Subject: **Request for Modification to Individual Permit Application and 401 Water Quality Certification** for the US 64 Relocation from US 19/74/129 in Murphy to east of NC 141 in Peachtree, Cherokee County. State Project No. 8.1910203. Federal Aid Project FR-14-1(1). TIP No. R-0977A. NCDOT Division 14. Debit \$570.00 from WBS Element 34357.1.1

The purpose of this letter is to request a modification of the existing Section 404 IP and Section 401 WQC. The activities and impacts occurring at each site are described, and revised project impacts are listed in Tables 1 and 2. Permit drawings and a Rapanos package are attached to this permit modification application. The EEP Acceptance Letter will be forwarded upon receipt by NCDOT.

PROJECT 8.1910203 (R-977A)
PROPOSED US 64 RELOCATION FROM
EXISTING US 19-74-129 IN MURPHY
TO EAST OF NC 141 IN PEACHTREE

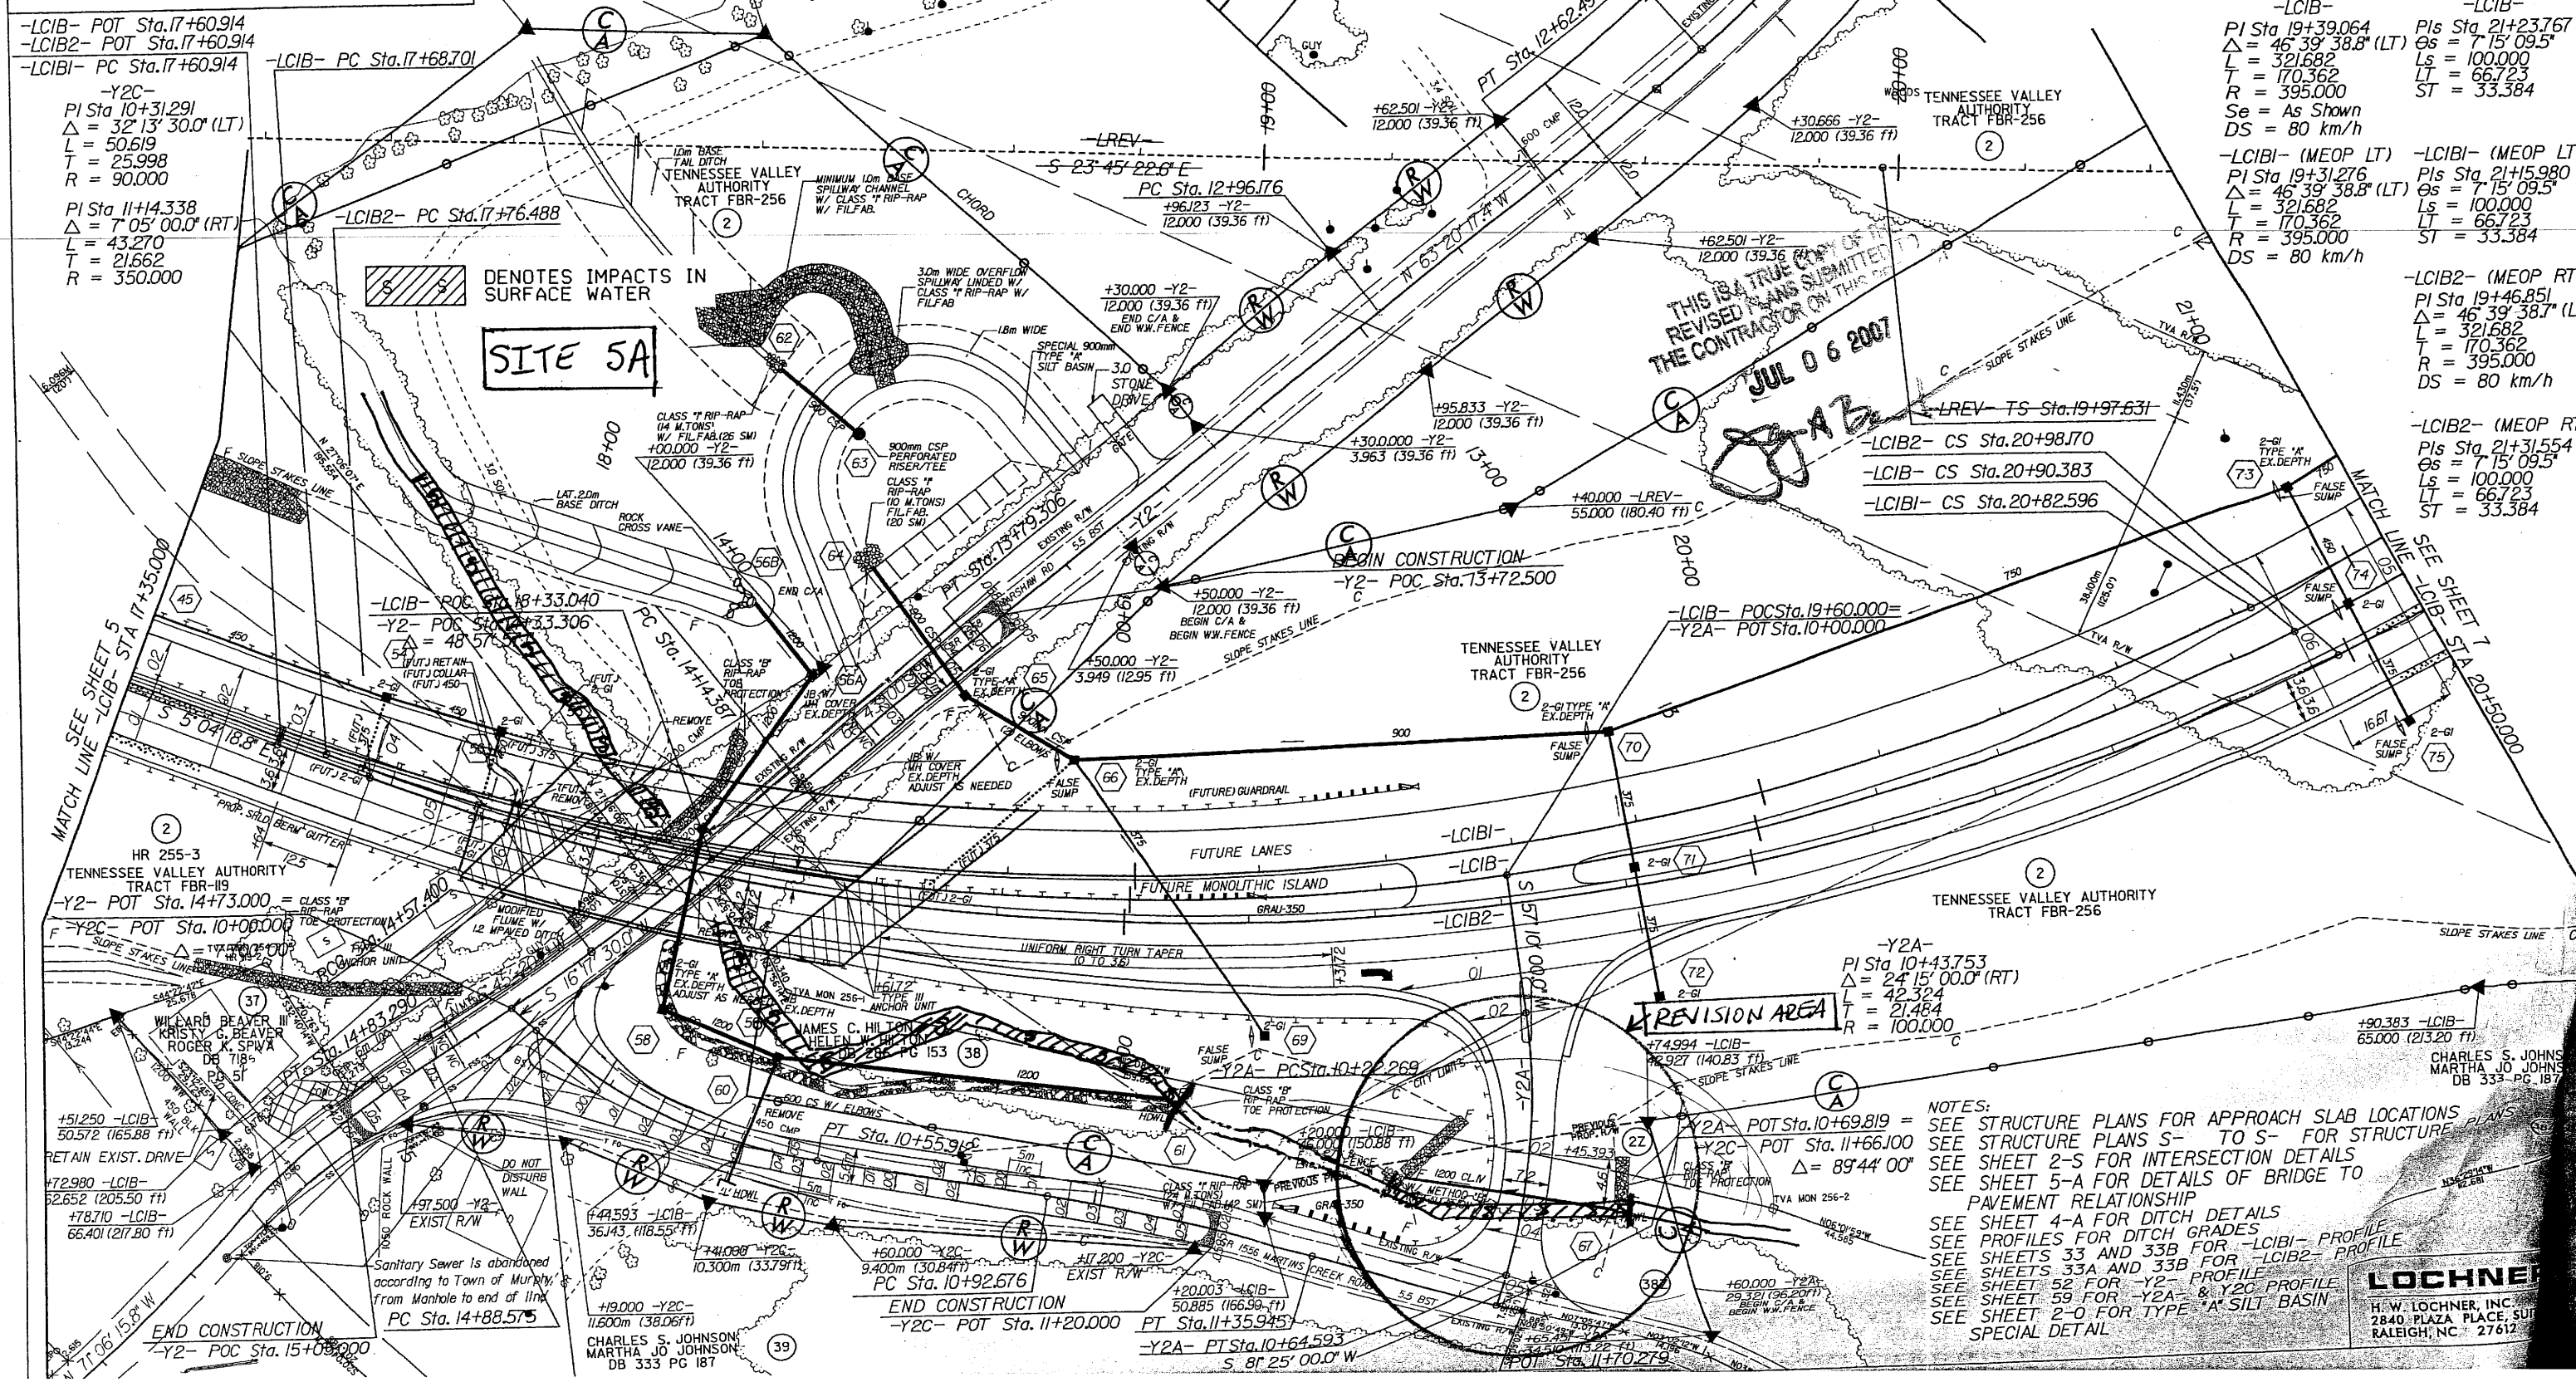
Modification activity at Station 10+55 -2A- (see Mod-April 2008 Site 5A Sheet)

In a resolution dated January 23, 2006, the Cherokee County Board of Commissioners requested that NCDOT provide access to the newly constructed US 64 from SR 1556 (Martins Creek Road) in the vicinity of Morgan Hill (Sta. 19+40 -LC1B-). This decision was based on increased traffic volume along Martins Creek Road and the undue hardship it would place on area residents to get to Murphy Medical Center and Tri-County Community College. The new Y-line (-Y2A-) will require the placement of 131 feet of RCP in an unnamed tributary to the Hiwassee River. There will be <0.01 acre of impacts due to dewatering for pipe installation.

Existing Permitted Impact: 518 linear feet

Revised Impact: 649 linear feet (131 LF of new impact)

New Temporary Impacts: <0.01 acre

Mitigation: needed for 131 linear feet of permanent stream impact.
